Proposed changes to the England
Coast Path at

Silloth Docks, Silloth, Cumbria

Natural England's Variation Report to the Secretary of State

**Coastal Access Variation Report GAL VR13
July 2022**

Map VR13a shows details of the proposed change to the route.

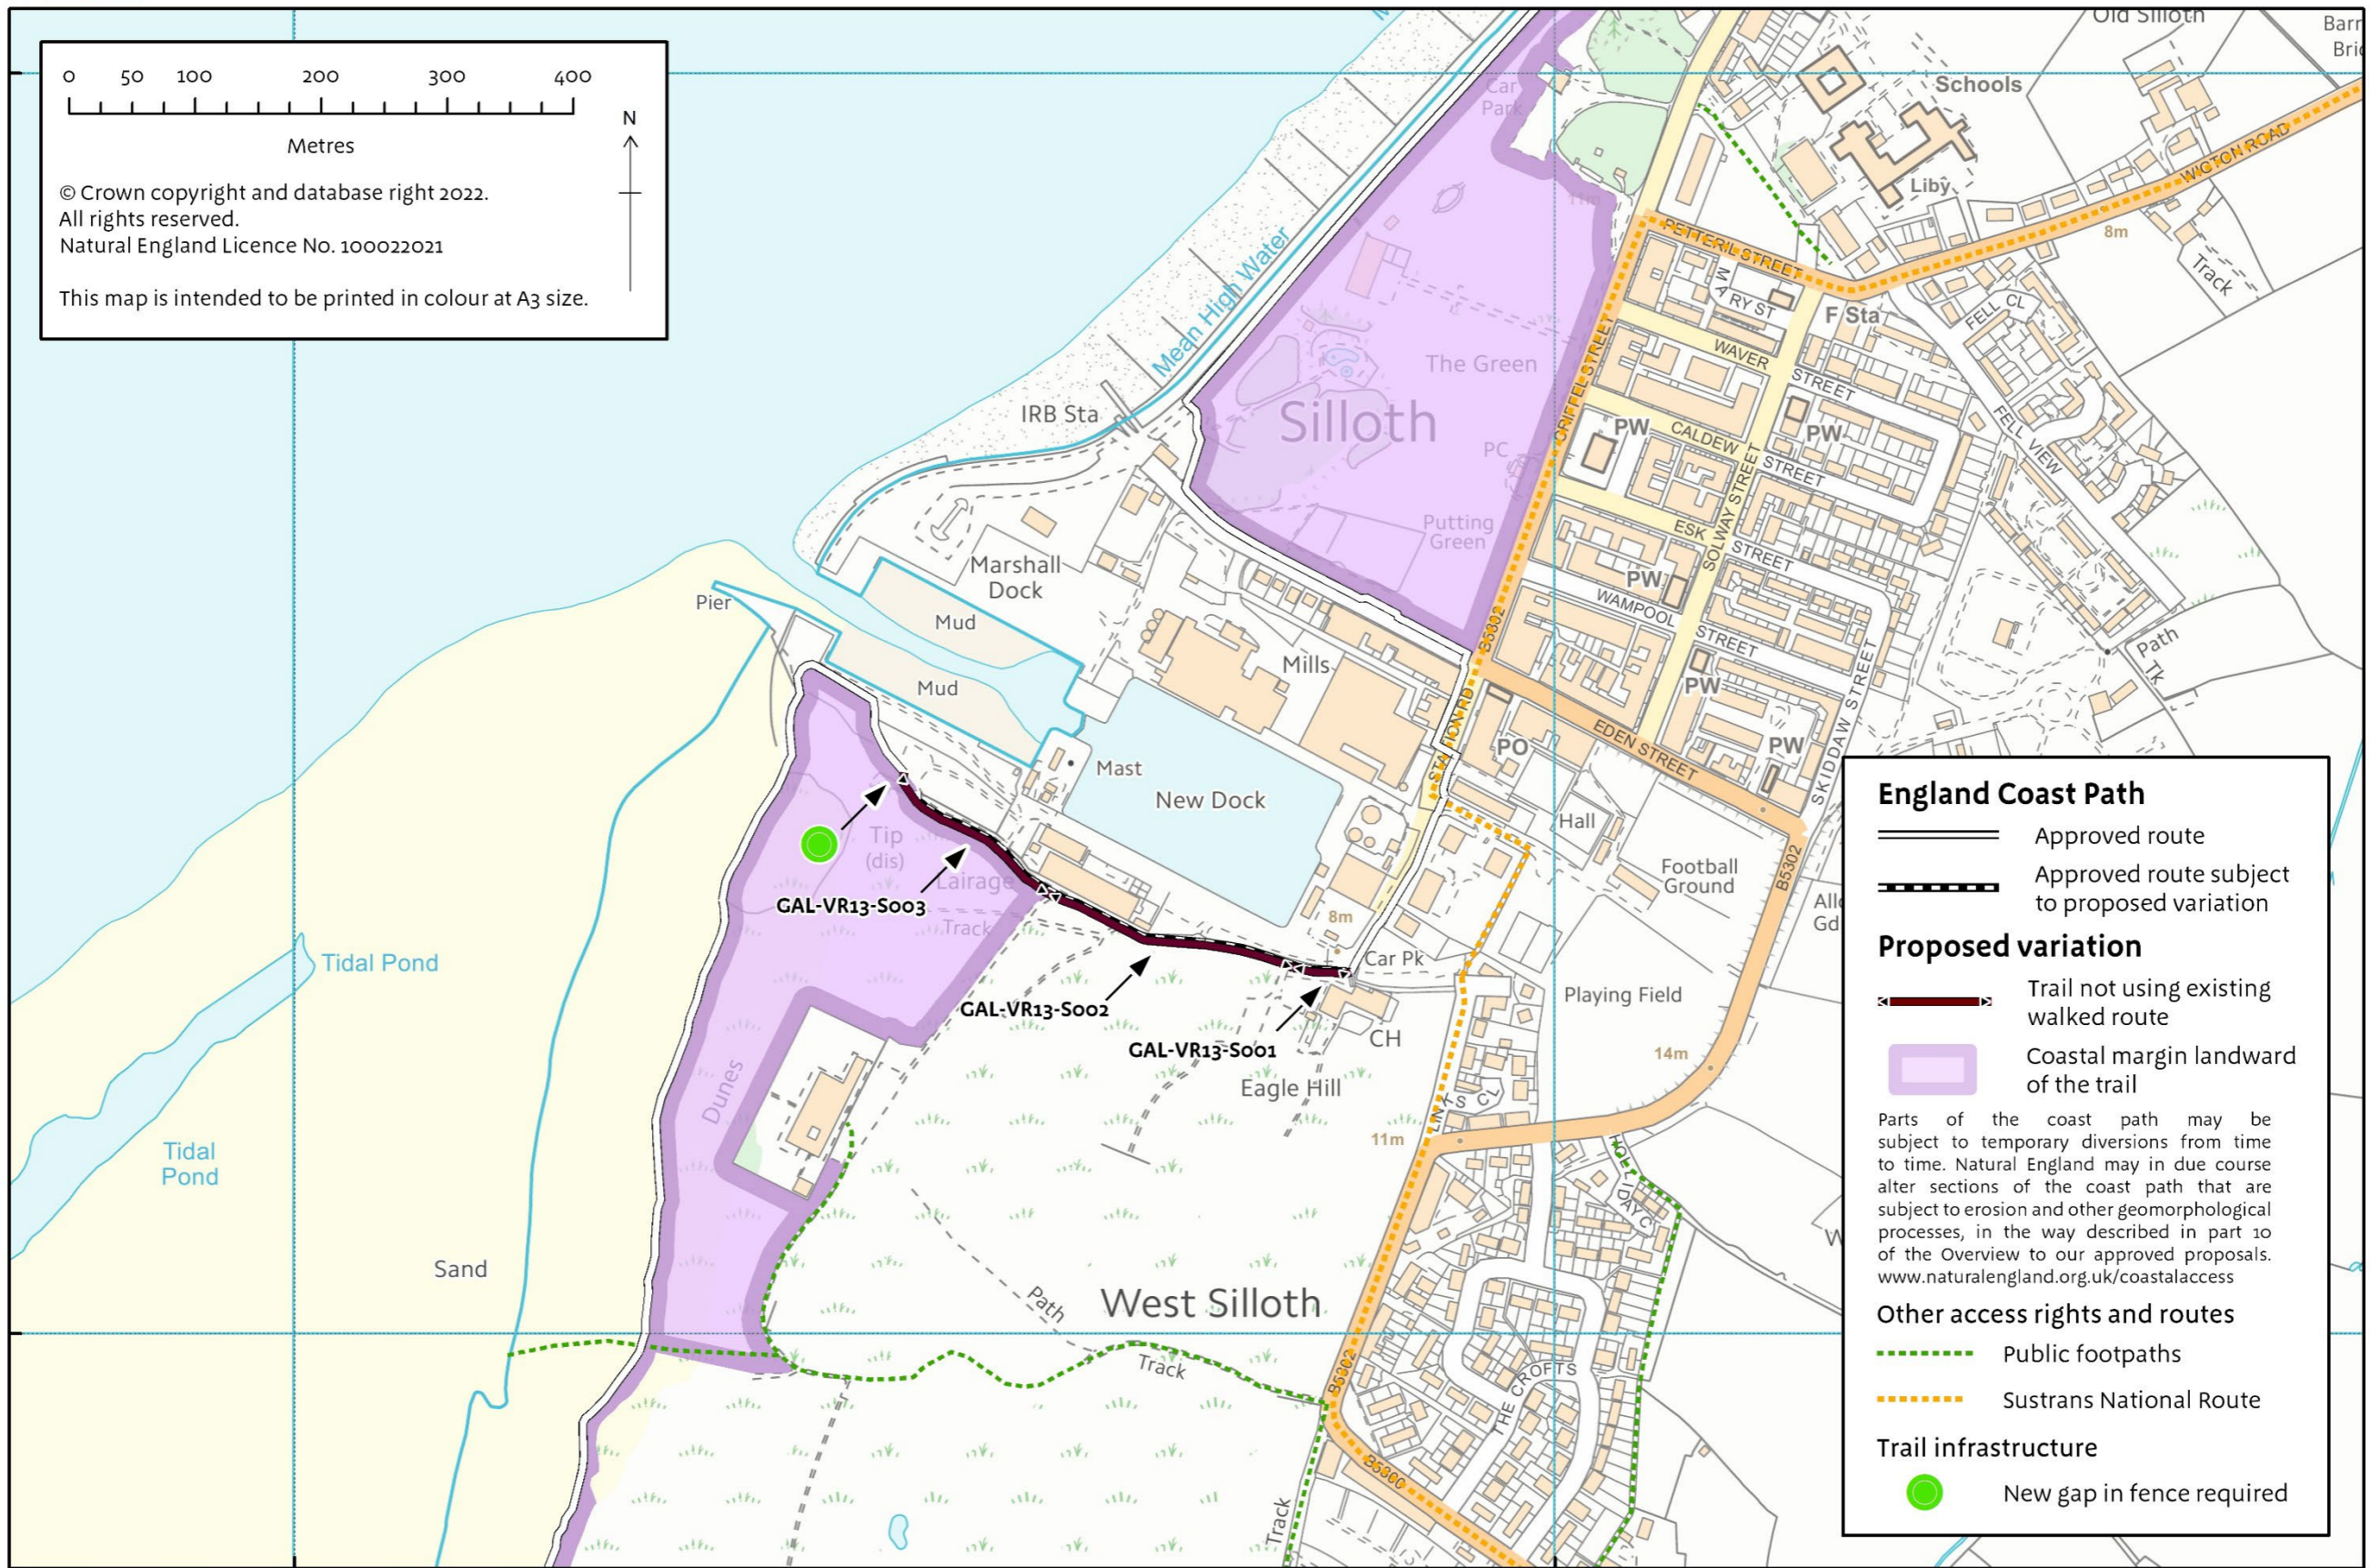
2.1.3 The proposed variation would involve the creation of a new route, between the golf clubhouse and the informal car park, parallel with and close to the southern side of the access track. Adjacent to the golf clubhouse, this would require some excavation to create a suitable path along the line of the grassy embankment. Further west, it would be necessary to clear some low-growing scrub to create a corridor for the proposed route.

- Would follow a new path across the grass bank at the front of the golf clubhouse, before crossing the entrance to the golf club car park;
- Would then follow a newly created path generally parallel to and a few metres from the existing vehicular track; and
- Finally, it would connect with the approved route in the vicinity of the existing informal car park, adjacent to the outer dock.
- Includes 3 sections of new path.
- Follows the coastline as closely as is possible in this area. Views of the sea are restricted by the dunes and the port infrastructure, which would similarly have been the case with the original route.
- Extends for a length of approximately 400 metres at a maximum of 5 metres south of the approved route.

2.2.14 During the preparation of this variation report, it has come to our attention that an error was included within Chapter 5 of the original Gretna to Allonby report. Whilst the text at paragraphs 5.3.10 to 5.3.12 of that report correctly describes the intended extent of the coastal margin, map GAL 5a did not show the same extent. This is now correctly depicted in map VR13a below.

Map VR13b - Key Statutory Environmental Designations - shows the extent of these designated sites in relation to the proposal.

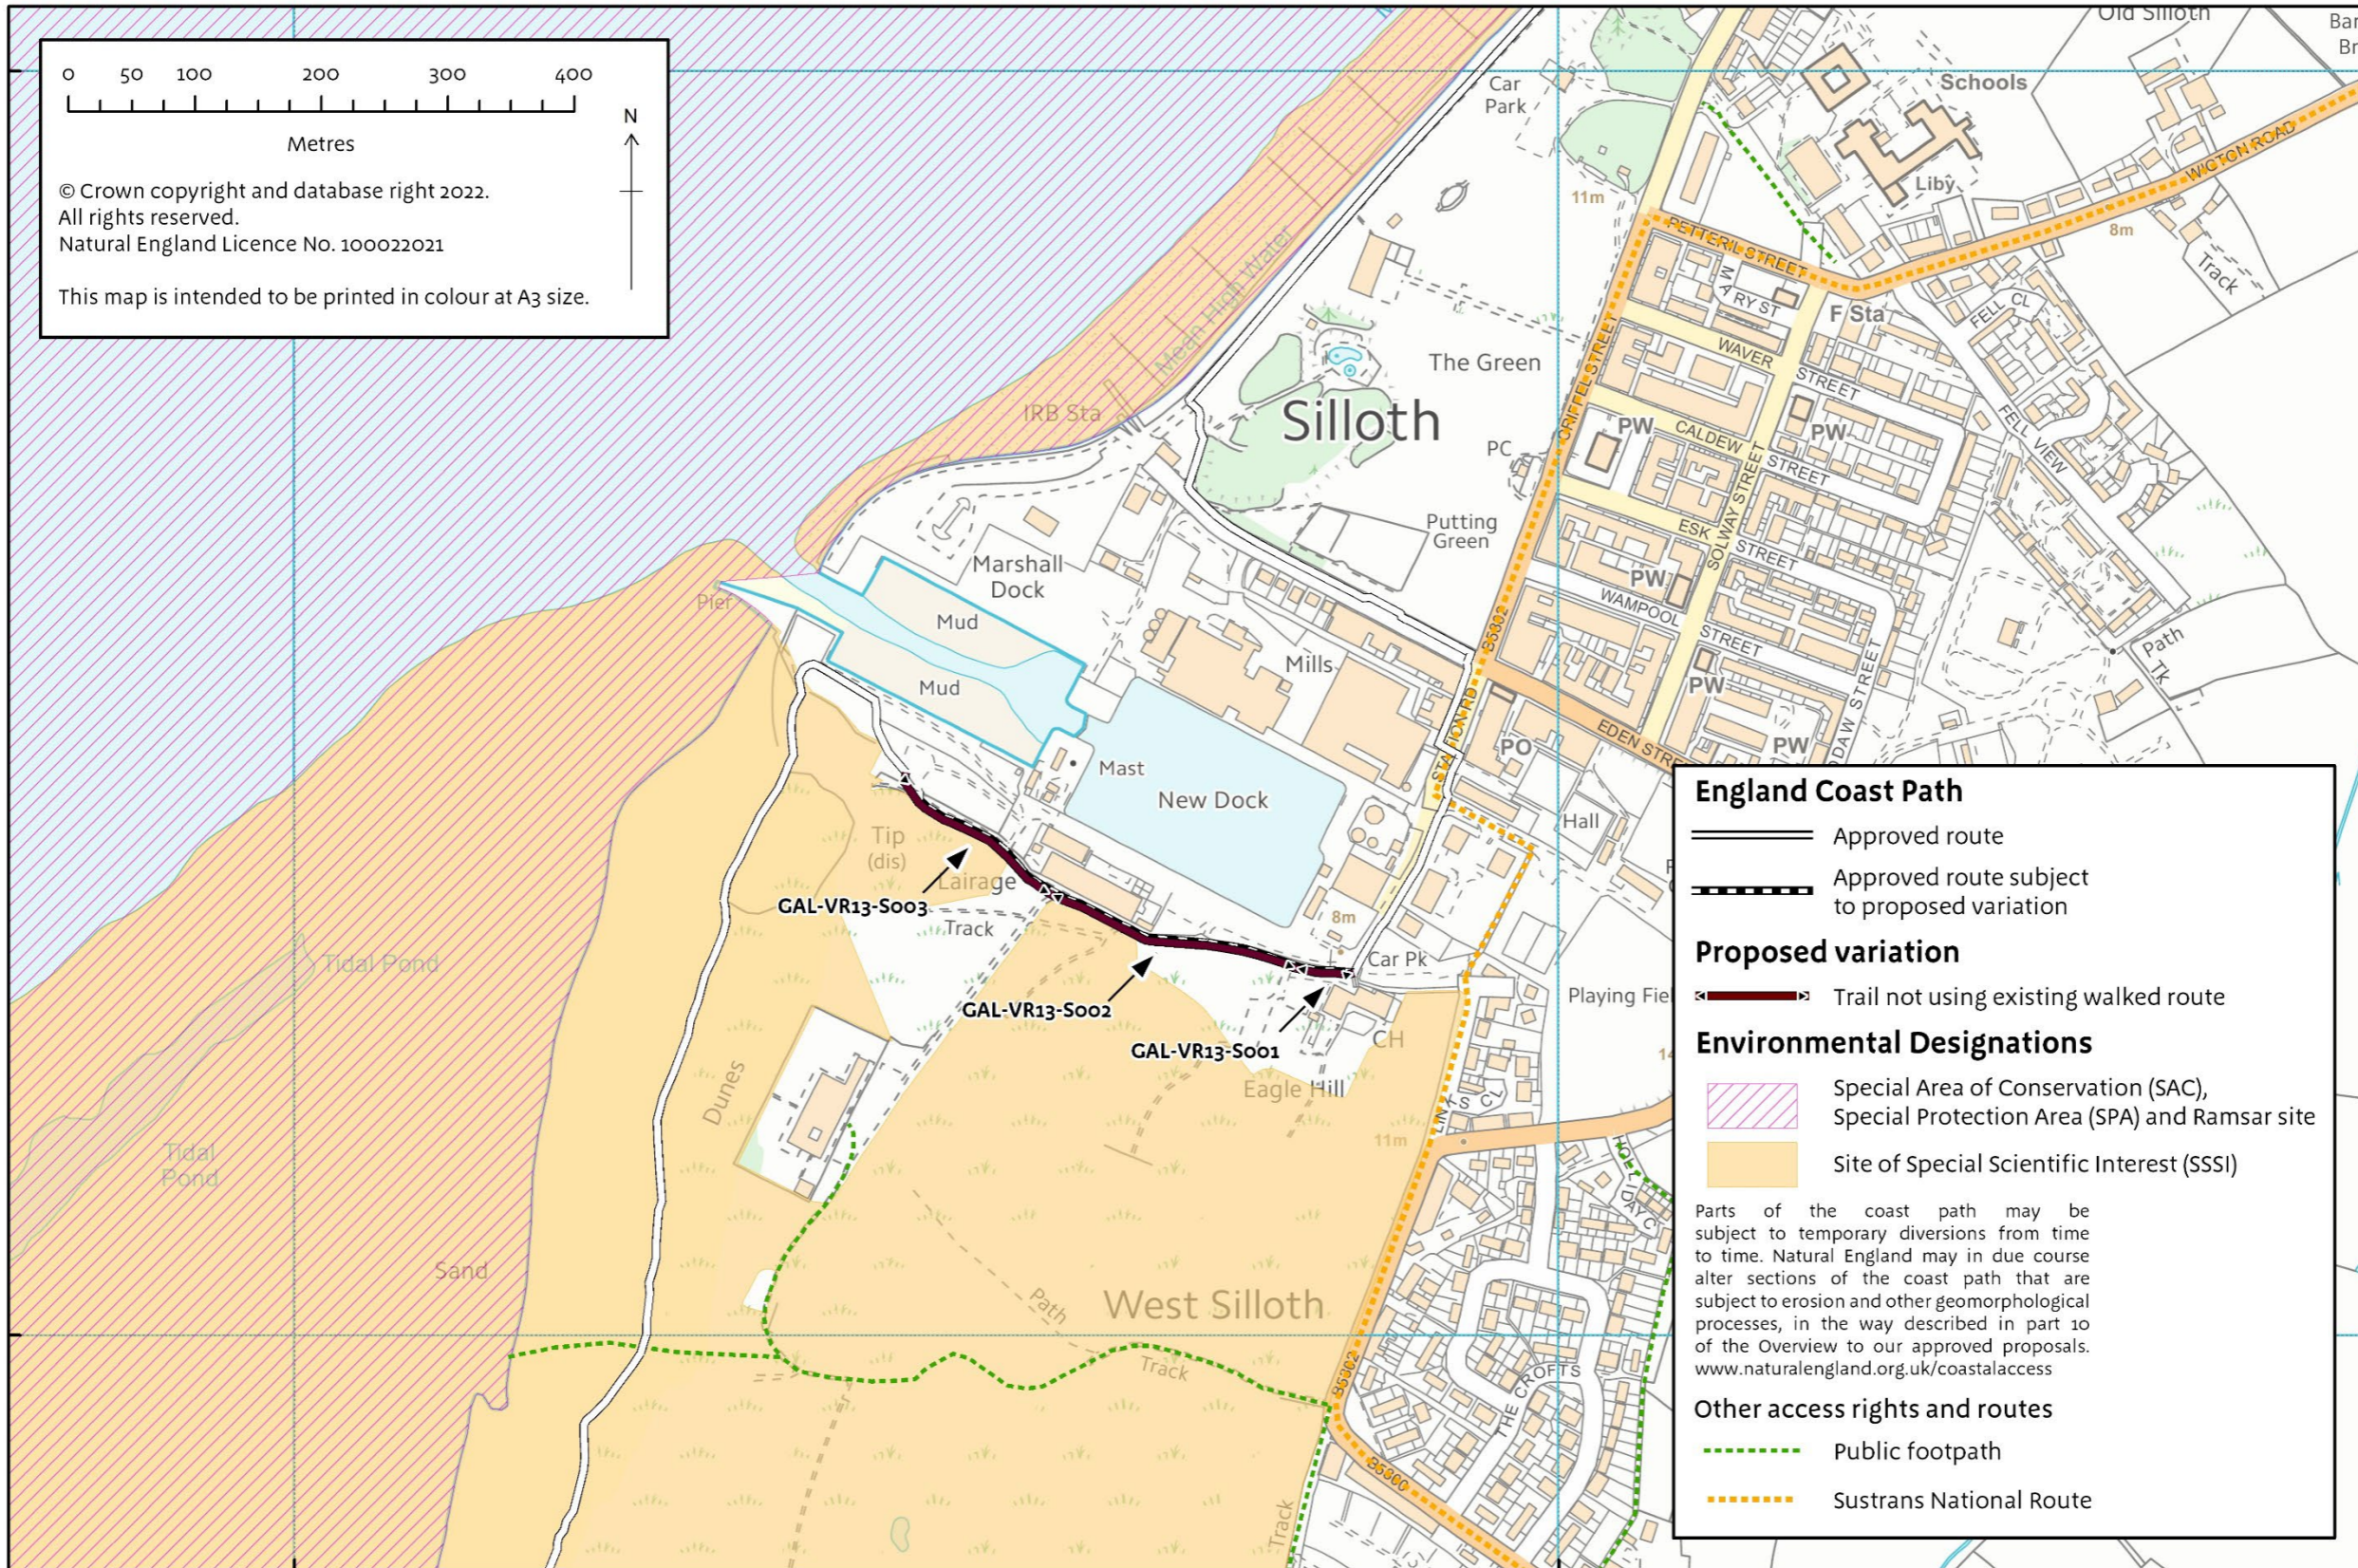
2.2.6 The proposed ECP is aligned just within the boundary of Silloth Dunes and Mawbray Bank SSSI, through an area of fixed dune grassland. We propose to clear a section of low-growing scrub at the edge of the vehicle track to provide walkers with a vehicle-free route. There is a low risk of the scrub removal impacting on the dune grassland. The vegetation work would be undertaken using a brush-cutter and can be accessed directly from an existing vehicle track, meaning there will be no vehicle movements across this habitat during path establishment. This part of the path would not be surfaced, so there will be no permanent loss of habitat.
